SUBJECT: FERMI-2 - AMENDMENT NO. 87 TO FACILITY OPERATING LICENSE
 NO. NPF-43 (TAC NO. M82102)

The amendment changes the licensed thermal power level of the reactor from the current limit of 3293 megawatts thermal (Mwt) to an increased limit of 3430 Mwt. This request is in accordance with the generic BWR power uprate program established by the General Electric Company and approved by the NRC staff in a letter dated September 30, 1991.

AMENDMENT NO. 87 TO FACILITY OPERATING LICENSE NO. NPF-43-FERMI-2

FIGURE 3.4.10-1

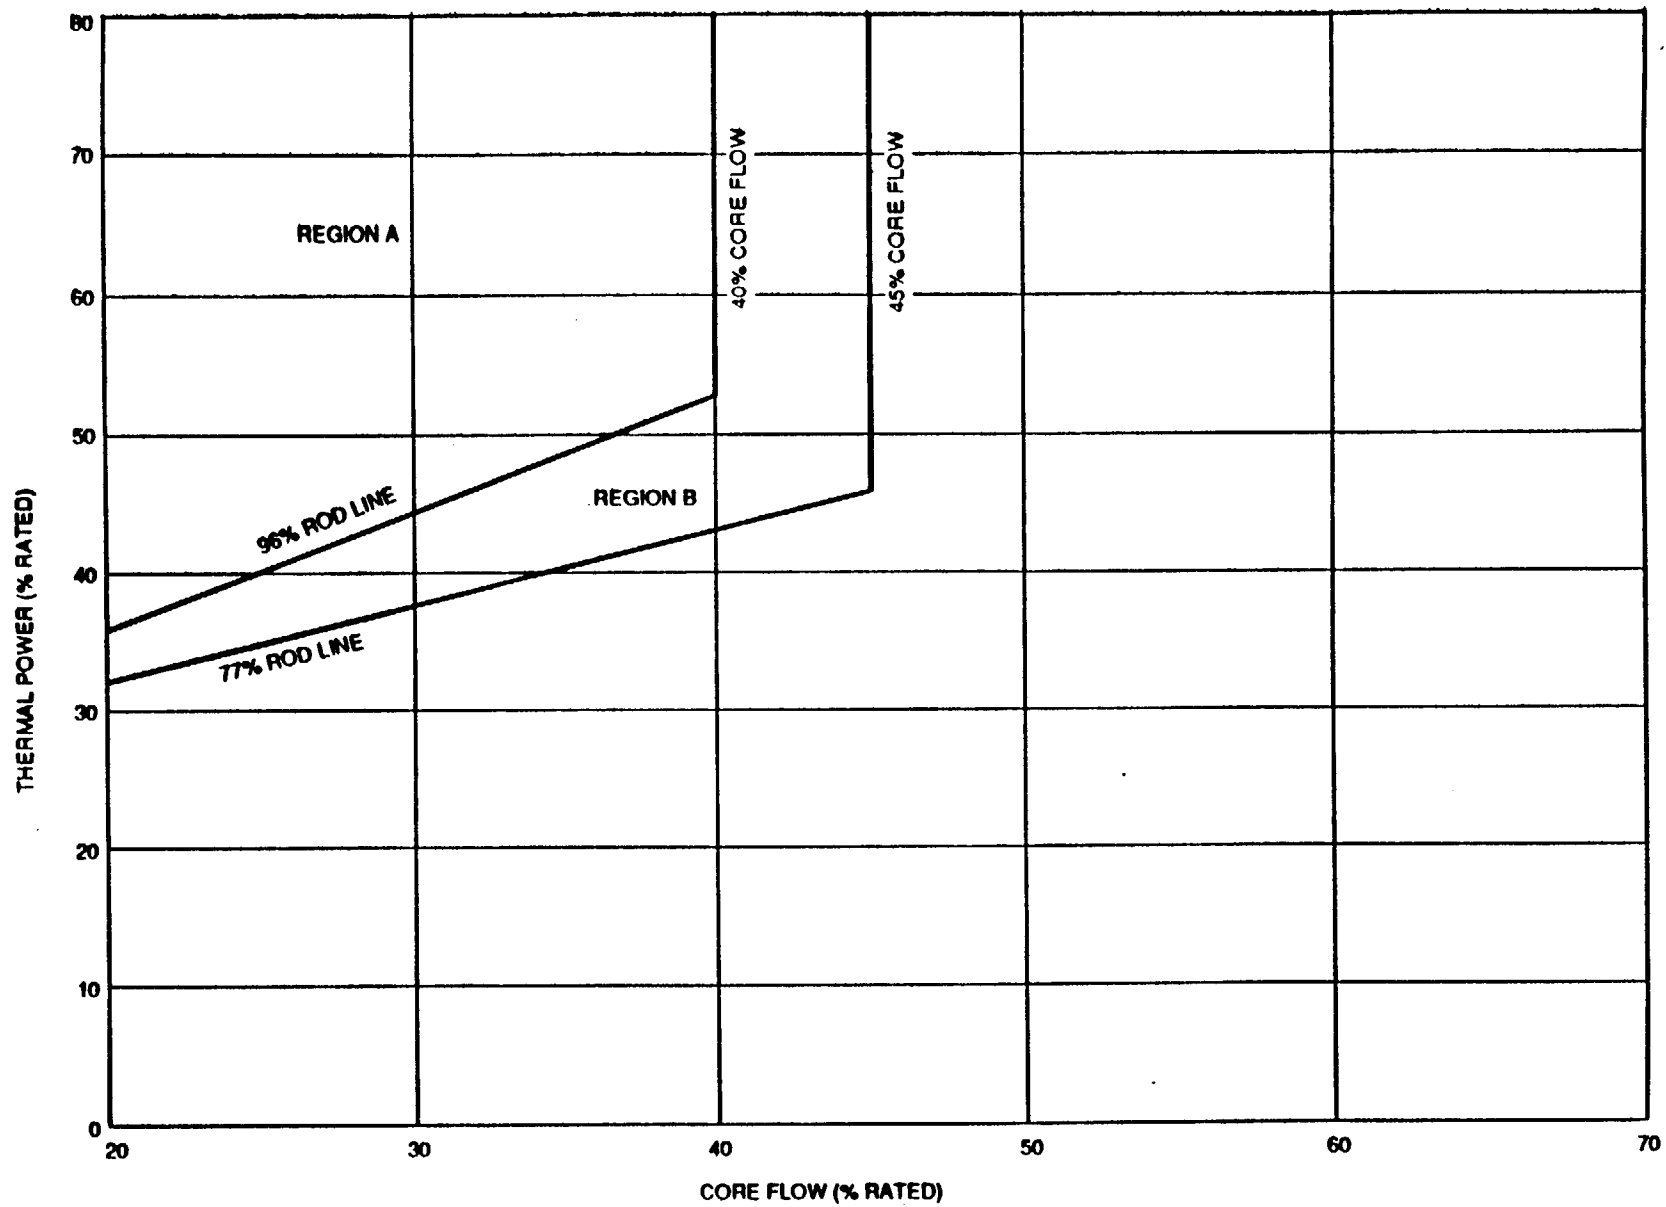
Region A and B of Figure 3.4.10-1 represent the least stable conditions of the plant (high power/low flow). Region A and B are usually entered as the result of a plant transient (for example, recirculation pump trips) and therefore are generally not considered part of the normal operating domain. Since all stability events (including test experience) have occurred in either Region A or B, these regions are avoided to minimize the possibility of encountering oscillations and potentially challenging the SLMCPR. Therefore, intentional operation in Regions A or B is not allowed. It is recognized that during certain abnormal conditions within the plant, it may become necessary to enter Region A or B for the purpose of protecting equipment which, were it to fail, could impact plant safety or for the purpose of protecting a safety or fuel operating limit. In these cases, the appropriate actions for the region entered would be performed as required.

Most oscillations that have occurred during testing and operation have occurred at or above the 96% rod line with core flow near natural circulation. This behavior is consistent with analysis which predict reduced stability margin with increasing power or decreasing flow. As core flow is increased or power decreased, the probability of oscillations occurring will decrease. Region A of Figure 3.4.10-1 bounds the majority of the stability events and tests observed in GE BWRs. Since Region A represents the least stable region of the power/flow operating domain, the potential to rapidly encounter large magnitude core thermal hydraulic oscillations is increased. During transients, the operator may not have sufficient time to manually insert control rods to mitigate the oscillations before they reach an unacceptable magnitude. Therefore, the prompt action of manually scramming the plant when Region A is entered is required to ensure protection of the SLMCPR.
